**Economic Commission for Europe****Inland Transport Committee****World Forum for Harmonization of Vehicle Regulations****Working Party on Passive Safety****Seventy-fourth session**

**UN Regulation No. 137 (Frontal impact with focus on restraint systems)****Proposal for the 04 series of amendments of UN Regulation  
No. 137 (Frontal collision with focus on restraint systems) \*****Submitted by the expert from Japan**

Model A

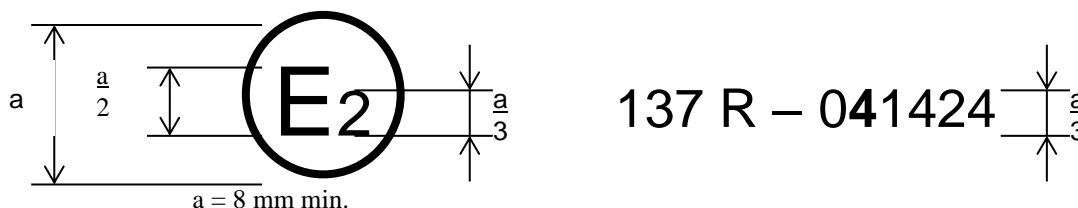
Annex 2, amend to read:

The above approval mark affixed to a vehicle shows that the vehicle type concerned has, with regard to the protection of the occupants in the event of a frontal collision, been approved in France (E 2) pursuant to Regulation No. 137 under approval number 0341424. The approval number indicates that the approval was granted in accordance with the requirements of Regulation No. 137 034 series of amendments.

Model B

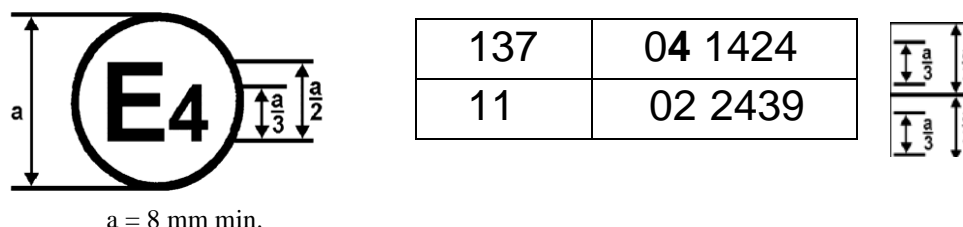
The above approval mark affixed to a vehicle shows that the vehicle type concerned has been approved in the Netherlands (E 4) pursuant to Regulations Nos. 137 and 11.<sup>1</sup> The first two digits of the approval numbers indicate that, at the dates when the respective approvals were granted, Regulation No. 137 incorporated the 034 series of amendments and Regulation No. 11 incorporated the 02 series of amendments."
